**Submission on Proposed Plan Change 7 – Rotokauri North Private Plan Change**

## Proposed Plan Change 7 Submission

Figure 15 -7a

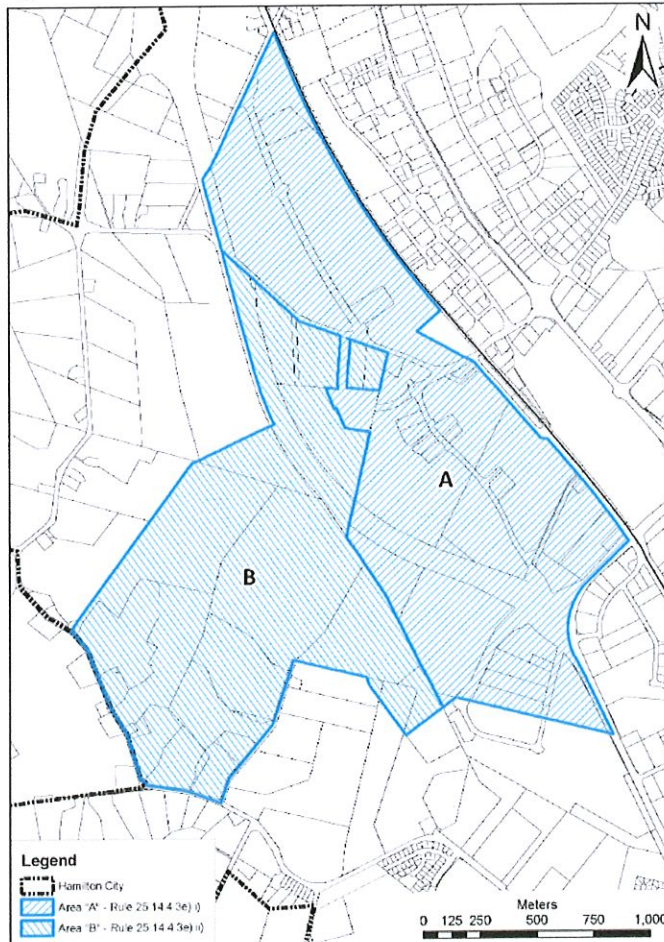
The proposed plan change is inconsistent with structure plan component *“3.6.3.2 Roading”* in its entirety. The proposed area is within the stage 2 area, outside of Areas A and B (see Figure 15-7a). The Rotokauri Structure Plan indicates that the release of land beyond stage 1A (such as the PPC): *“will be contingent upon the availability of network capacity which may arise as a result of traffic generation”* and 3.6.2.3 d and e) provide that:

*Proposals for the development of land in ‘Area B’ on Figure 15-7a will require careful scrutiny to ensure that adequate network capacity exists to support the development, or will be provided as part of the development and they will not compromise the development of land in ‘Area A’ on Figure 15-7a. Development will require:*

e) The development of land outside Areas 'A' and 'B' (Figure 15-7a) will need to coincide with the northwards extension of Rotokauri Minor Arterial Road to connect with Te Kowhai Road at the City Boundary.

The PPC is clearly contrary to these provisions, and the developer is trying to dodge the full cost of developing ahead of the planned sequencing by exempting itself from these Rotokauri Structure Plan provisions. The PPC does not provide adequate transport network capacity outside of the PPC area to support the proposed development. The proposal does not achieve a sustainable expansion of the city and does not represent coherent and integrated development, because the transportation effects beyond the Rotokauri North boundaries have not been resolved.

- Either decline the private plan change; or
- Decline proposed inclusion of section 3.6 d (exemption of PPC area from Rotokauri Structure Plan), but approve the development subject to requiring the developer to adhere to all existing Rotokauri structure Plan provisions, including:
  - a) requiring they construct the Rotokauri Minor Arterial Road;
  - b) provide an ITA that adequately assesses impacts on the wider transport network and have that ITA peer reviewed.
  - c) cater for the demand generated within the wider transport network;

- d) requiring the developer to fund all necessary road network upgrades and additions.
- e) provide a full economic assessment of the financial impact on the remainder of the Rotokauri Structure plan area and including the likely cost of the required roading upgrades.
